PCN# 20151016001A
Qualification of AMKOR P1 as Additional Assembly and Test Site for Select SOIC Package Devices
Change Notification / Sample Request

PCN Number:	20151016001A	PCN Date:	10/27/2015
Title:	Qualification of AMKOR P1 as Additional Assembly and Test Site for Select SOIC Package Devices		
Customer Contact:	PCN Manager	Dept:	Quality Services
Proposed 1st Ship Date:	01/22/2016	Estimated Sample Availability:	Date Provided at Sample request

Sample product shipping label (not actual product label)

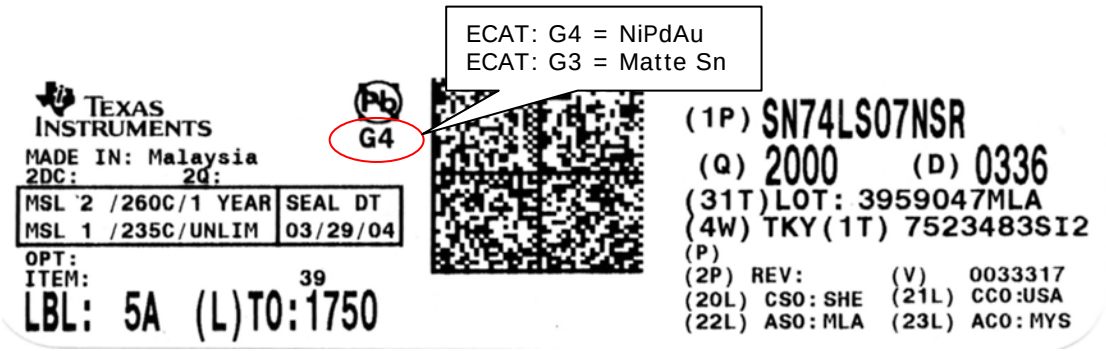
Changes to product identification resulting from this PCN:

Assembly Site			
TI Mexico	Assembly Site Origin (22L)	ASO: MEX	ECAT: G4
TI Malaysia	Assembly Site Origin (22L)	ASO: MLA	ECAT: G4
ASESH	Assembly Site Origin (22L)	ASO: ASH	ECAT: G3
Amkor P1	Assembly Site Origin (22L)	ASO: AKR	ECAT: G3

ASSEMBLY SITE CODES: TI-Mexico = M , TI-Malaysia = K , ASESH = A , AP1 = 4
